Re: NSW Ports Submission to SSI-10049 Kamay Ferry Wharf Project

Thank you for your letter dated 14 July 2021 and for providing NSW Ports with the opportunity to comment on SSI-10049 Kamay Ferry Wharf Project (the Proposal). NSW Ports is responsible for managing the port and freight assets of Port Botany, Port Kembla, the Cooks River Intermodal Terminal and the Enfield Intermodal Logistics Centre (ILC). These assets, along with the efficient movement of freight to and from these assets, are critical to the future economic growth, liveability, productivity and sustainability of New South Wales.

Figure 1 - Three Ports SEPP Referral Area and Proposal Location

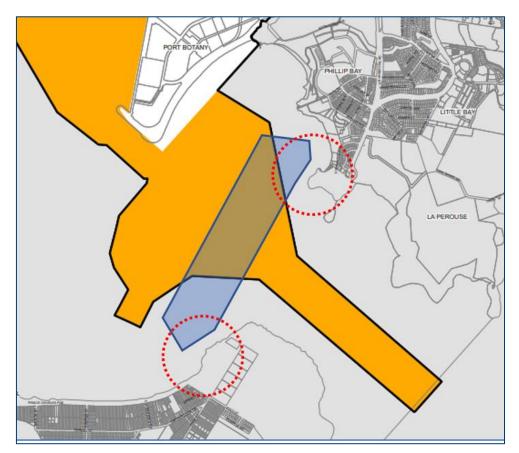
Figure 1, below, provides a portion of the Referral Area Map (to which Clause 19 applies) with the Referral Area identified in yellow. This has been overlaid with the information provided in Figure 5-1 of the Environmental Impact Statement for the Proposal with the ferry swept path identified in blue.

Given the ferry route traverses the Referral Area, NSW Ports is of the opinion that Clause 19 of the Three Ports SEPP applies and as such this is a submission made in accordance with Clause 19(4)(a) of the Three Ports SEPP.
